**FEDERAL PLAZA WEST
SKETCH PLAN NO. 320220100 AND
PRELIMINARY PLAN NO. 120220140**

Description

Nos. 320220100, 120220140
Completed: 6-30-2023

MCPB
Item No.
07-13-2023

PHASE I PLAN

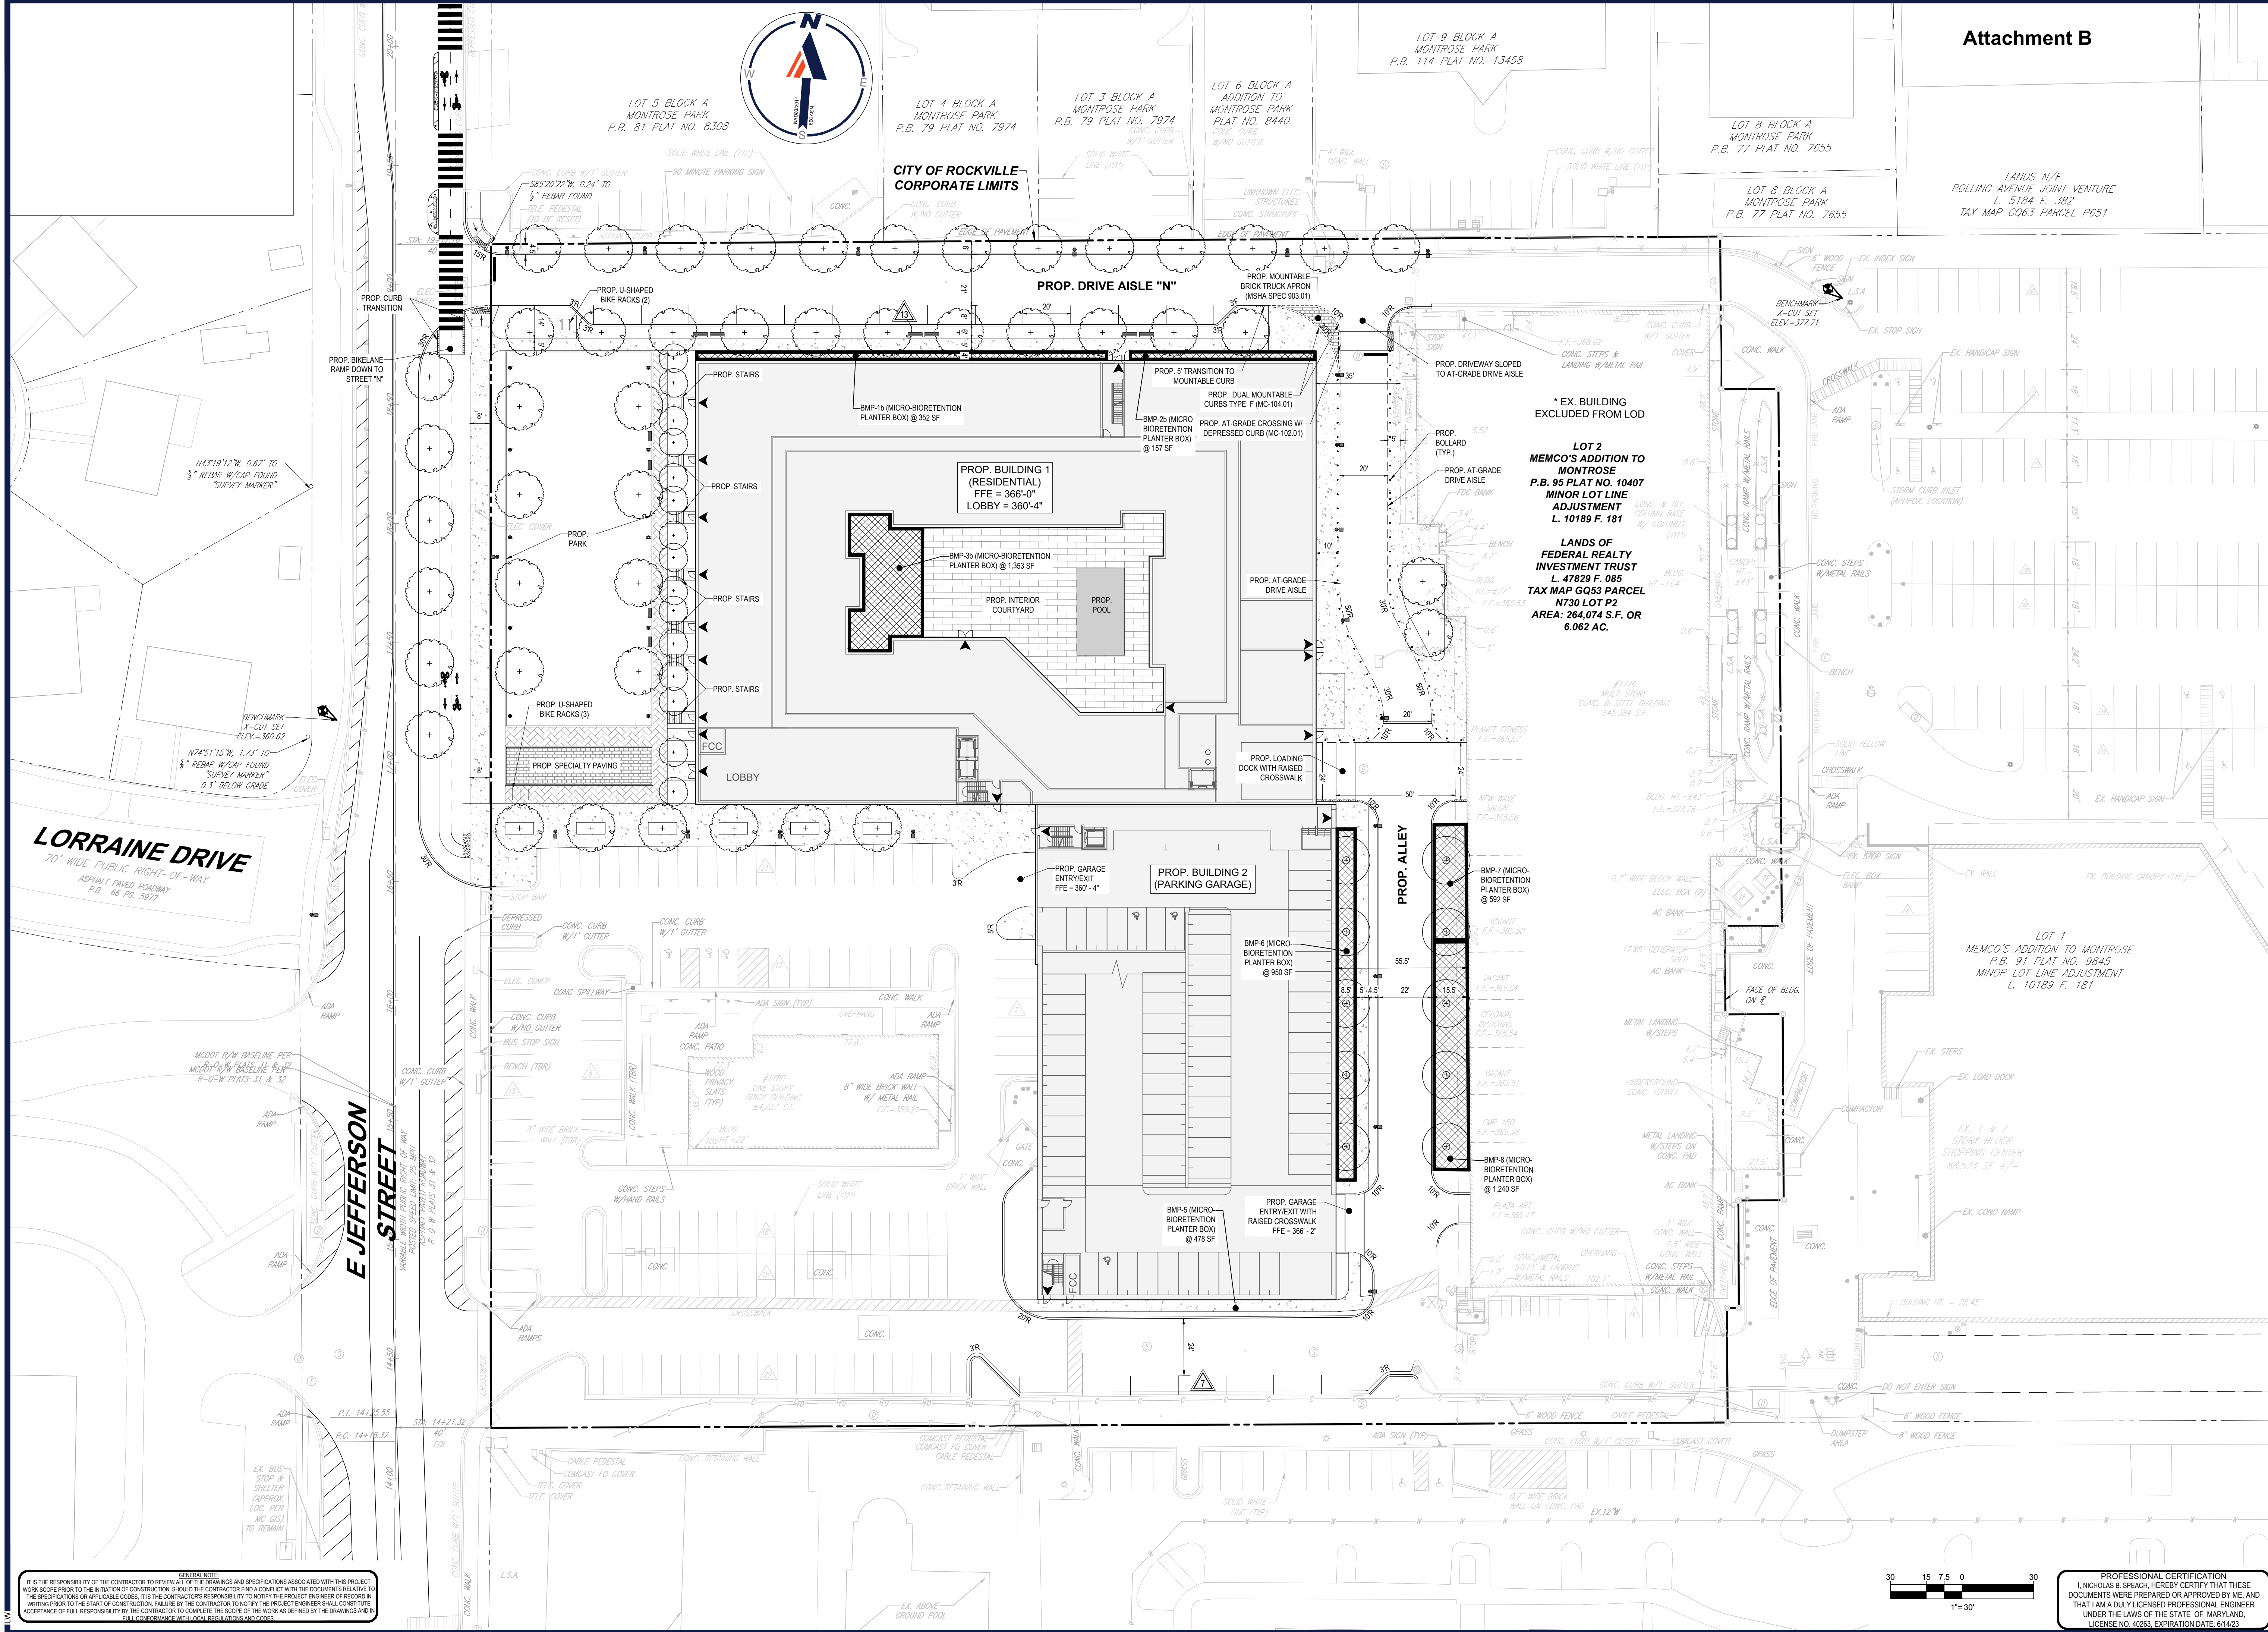
- 2. We agree with the phasing of the right-of-way improvements.
 - a. Sheet# 3-Phase I Plan:
 - i. As part of Phase I, the applicant shall be responsible for installing the ultimate road cross section for E. Jefferson Street up to the east-west street between Street 'S' and northernmost Drive Aisle and an interim two-way bike lane with buffer from the east-west street (between Street 'S' and northernmost Drive Aisle) to the existing California Circle located just to the south of proposed Street 'S'.
